## ARBORIST RESPONSE TO CITY REVIEW COMMENTS

REFERENCE: Arborist Response to City Review Comments RE: SUB22-009 (Cui Preliminary Short Subdivision)

SITE ADDRESS: 4833 90<sup>th</sup> Ave SE, Mercer Island, WA

Figure 1. Diagram showing reduced house footprint necessary to preserve Tree #55.

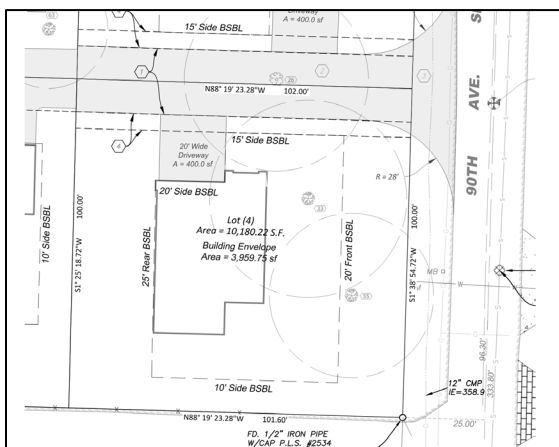
**2. Tree 55 is a viable exceptional tree over 24 inches in diameter proposed for removal. Please speak to the code for justification of the removal of viable trees according to MICC 19.10.060(A)(3). Discuss and show in a diagram how if you protect the tree, you would not be able to obtain at least 85% of your maximum gross floor area. If this is the section of code you think best describes the reason for removing this tree.**

Arborist Response: The below diagram illustrates a reduced building footprint for Lot 4 to adequately retain Tree #55. The reduced footprint results in a gross floor area of less than 85-percent of the allowable GFA per MICC 19.02.020(D) and, as such, the criteria of MICC 19.10.060(A)(3) are met supporting tree removal.
